NSLPP MEETING HELD ON 01/02/2023

ADDRESS/WARD: 27 Elamang Avenue, Kirribilli (C)

APPLICATION No: DA 288/22

PROPOSAL: Alterations and additions to a dwelling and associated work.

Figure 12. The building height blanket diagram.

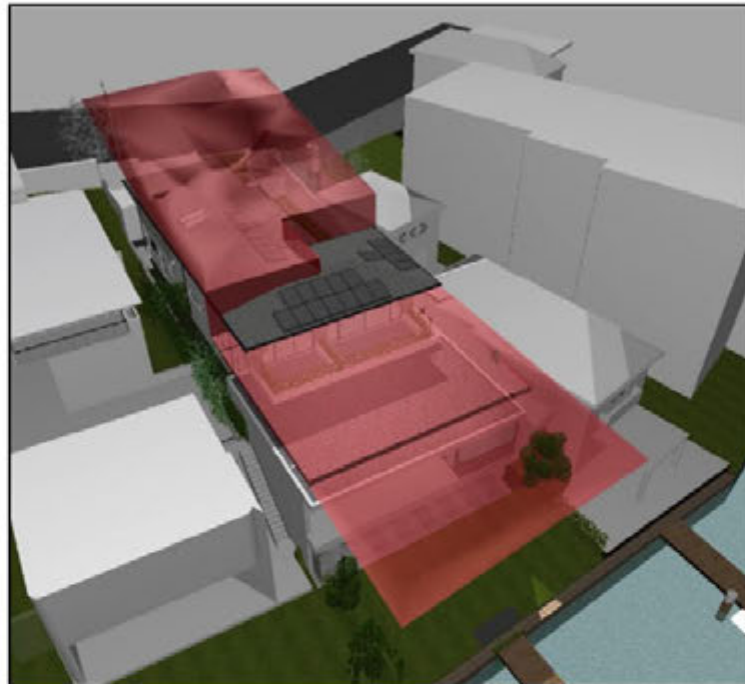
Principal Development Standards – North Sydney Local Environmental Plan 2013			
Clause	Proposed	Control	Complies
Clause 4.3 – Heights of Building	Existing: 7.302m Proposed: 10.5m (2m/23.5%)	8.5m	No

Due to the steep natural fall of the site and the existing excavated ground level of Level 1, a section of the top of Level 3 and the roof of the eastern end of the dwelling is above the 8.5m high limit at 10.5m (2m or 23.5%). Consequently, this requires a variation of the Development Standard in clause 4.3 in NSLEP 2013 (see discussion below).

Figure 19. Left: the current outlook/view from the loungeroom of Unit 10. Right: Annotated view of the outlook from the loungeroom of Unit 10 showing the proposed development and the level of water view loss represented by the proposal.

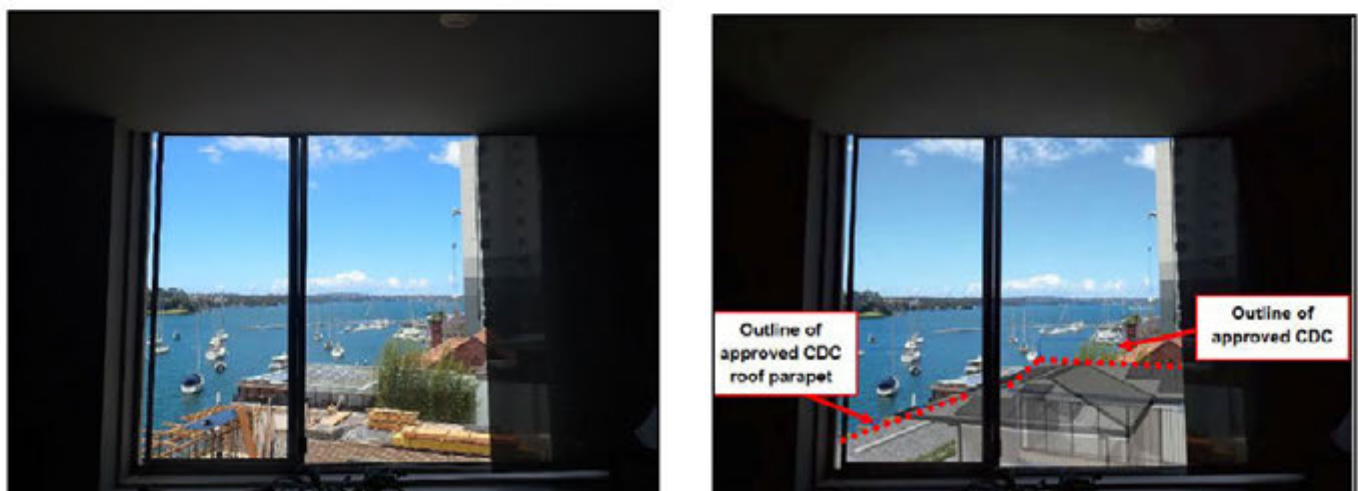
Loungeroom – The loungeroom would retain the vast majority of its water view and district/harbourside views to the northeast but would lose a very minor lower section of the water view due to the new roof level of the development. This loss will partially be created through the Level 3 addition of the subject site, particularly within the north-western corner of the addition that is non-compliant with the height limit. Nevertheless, this overall view and general outlook will be retained by the proposal as the majority of the lower part of the water view is already obstructed by existing buildings on the subject site.
